Address:	389 Kentish Town Road London NW5 2TJ		1
Application Number:	2013/4816/P	Officer: Hugh Miller	
Ward:	Kentish Town		
Date Received:	30/07/2013		
Proposal: Erection of single-storey extension at rear ground floor level, including formation of new windows at rear ground floor level; installation of extraction duct at rear roof level, including air conditioning units at ground level north elevation to existing public house building (Use Class A4).

OFFICERS' REPORT

FRONT ELEVATION A - A

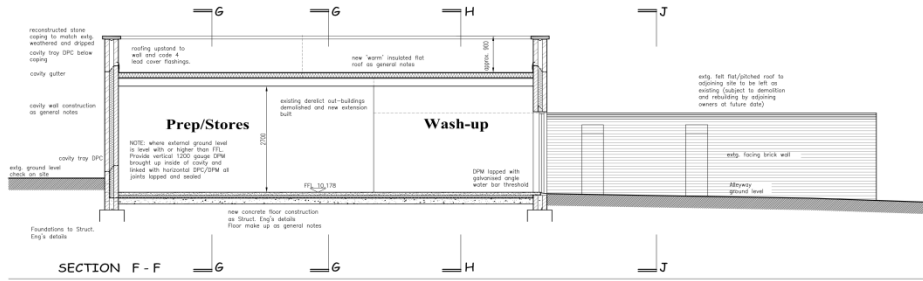
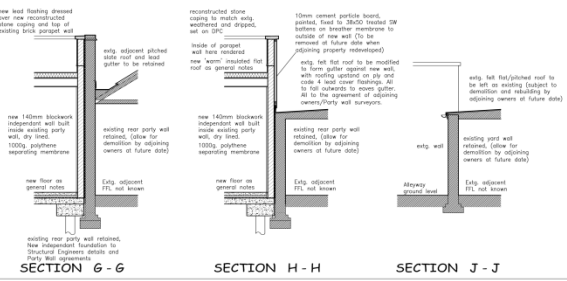
6.5 The shopfront façade of the public house currently contains inappropriate non-original stall riser tiles and plastic glazing in place of the curved glass. The left

entrance has been in-filled, which appears incomplete and not in-keeping with the otherwise attractive façade. At ground frontage level, the proposed works would create a new entrance to the left of the pub and reinstate the curved glass; new timber framed and glazed doors and matching stall riser would be added. It is considered that the frontage works would enhance the appearance and interest of the listed building.

REAR ELEVATION B - B

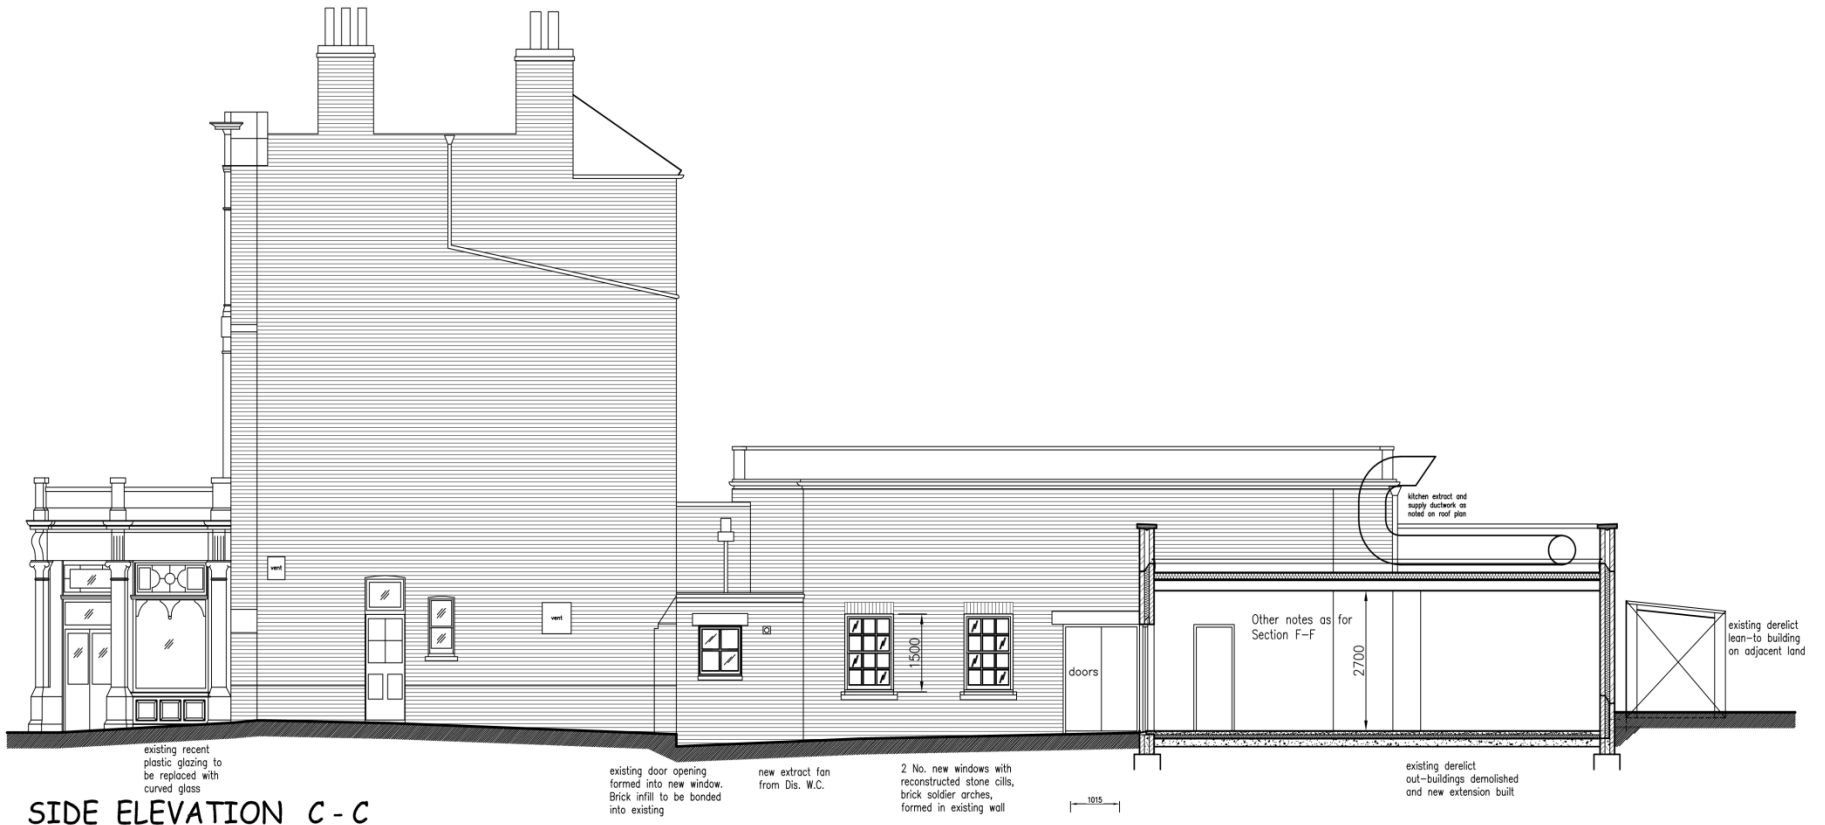
- a. 10*. Formation of new window openings with lintels over new window frames. We object to the two- pane sash windows proposed on the Plan as they are out of keeping with the architecture of the pub. The windows into the dining area should have 8 to 12 panes.

Officer Comment: a] *The fenestration pattern of the proposed rear flank windows has been changed to 6 over 6 (12 panes) windows to satisfy objections.*
